# Groundwater Application Review Summary Form

Application # ~~B~~<sup>LL</sup> 1685

GW Reviewer DENNIS ORLOWSKI Date Review Completed: 5/10/2017

TO: Water Rights Section Date 05/10/2017  
 FROM: Groundwater Section \_\_\_\_\_ Dennis Orłowski \_\_\_\_\_  
Reviewer's Name  
 SUBJECT: Application LL- 1685 \_\_\_\_\_ Supersedes review of \_\_\_\_\_  
Date of Review(s)

LL-1685 - SW1 (Unnamed tributary)

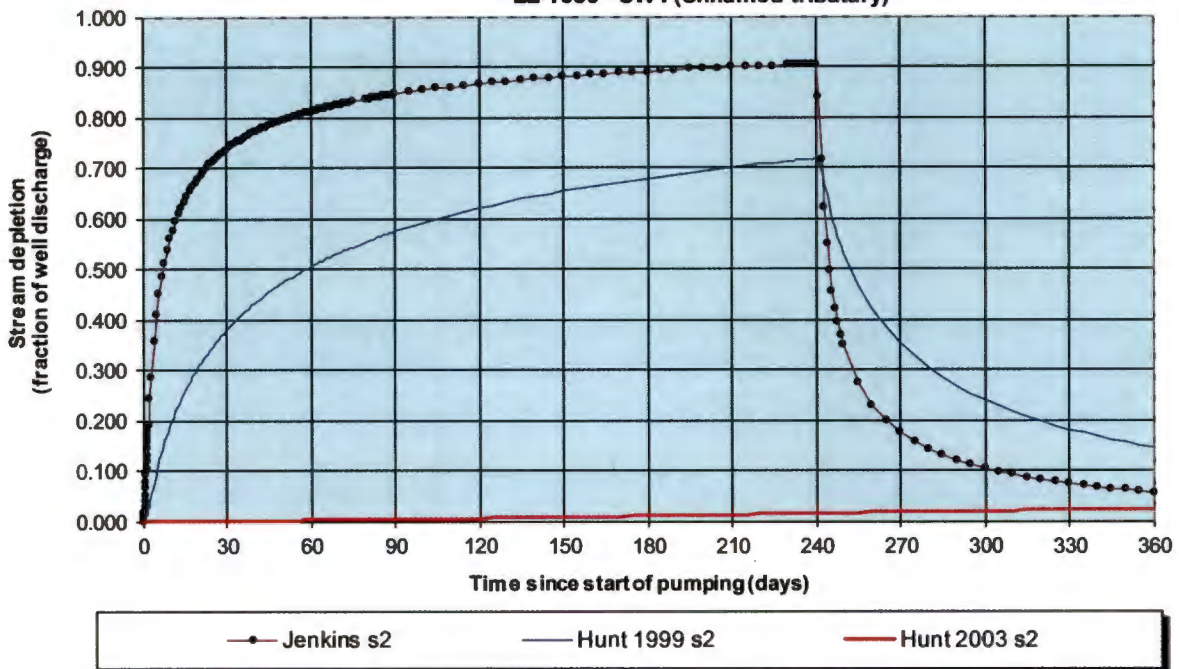
C3a: Potential depletion of SW1 (unnamed tributary to the South Yamhill River) was estimated using the Hunt 2003 analytical stream depletion model (Hunt, 2003). Aquifer parameters used for the model are typical of those reported for this hydrogeologic regime (Conlon and others, 2003, 2005; Iverson, 2002; Woodward and others, 1998).

The Hunt 2003 analytical modeling results indicate that depletion of SW1 is expected to be substantially less than 25% (of well discharge) after 30 days of continuous pumping.

C3a: The Hunt 2003 analytical modeling results indicate that depletion of SW1 is expected to be substantially less than 25% (of well discharge) after 30 days of continuous pumping.

LL-1685 - SW2 (Salt Creek)

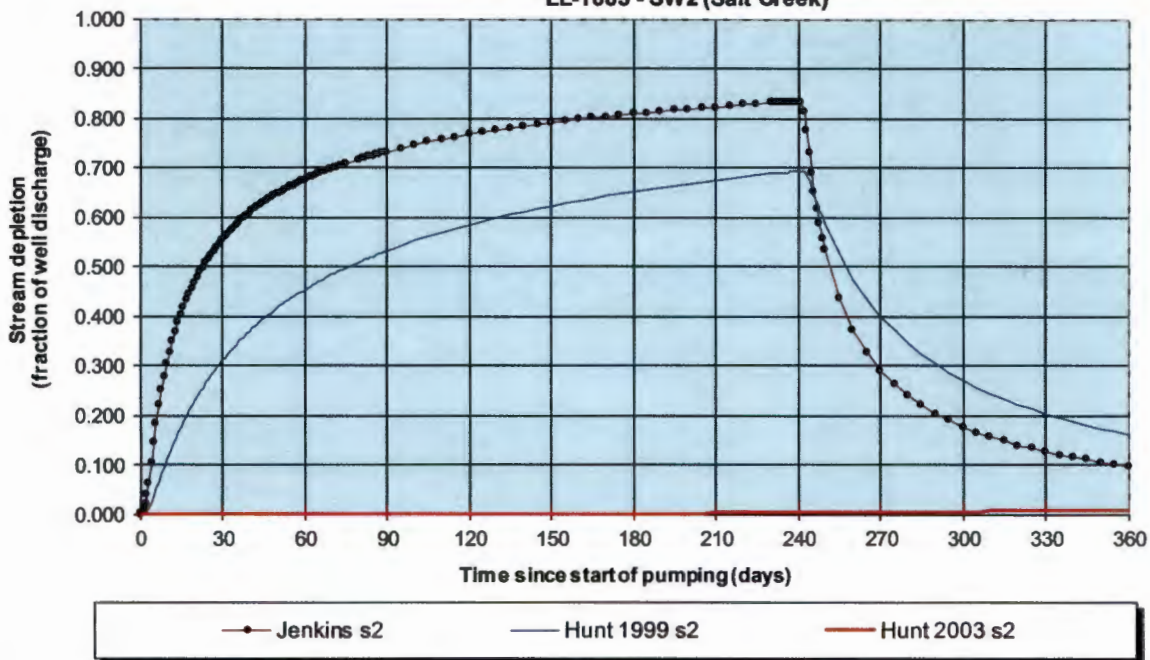
C4a: Potential depletion of SW2 (Salt Creek) was estimated using the Hunt 2003 analytical stream depletion model (Hunt, 2003). Aquifer parameters used for the model are typical of those reported for this hydrogeologic regime (Conlon and others, 2003, 2005; Iverson, 2002; Woodward and others, 1998).

The Hunt 2003 analytical modeling results indicate that depletion of SW2 is expected to be nearly inconsequential one year after pumping of proposed Well 1 begins.

Potential stream of SW2 is expected to be nearly inconsequential one year after pumping of proposed Well 1 begins.
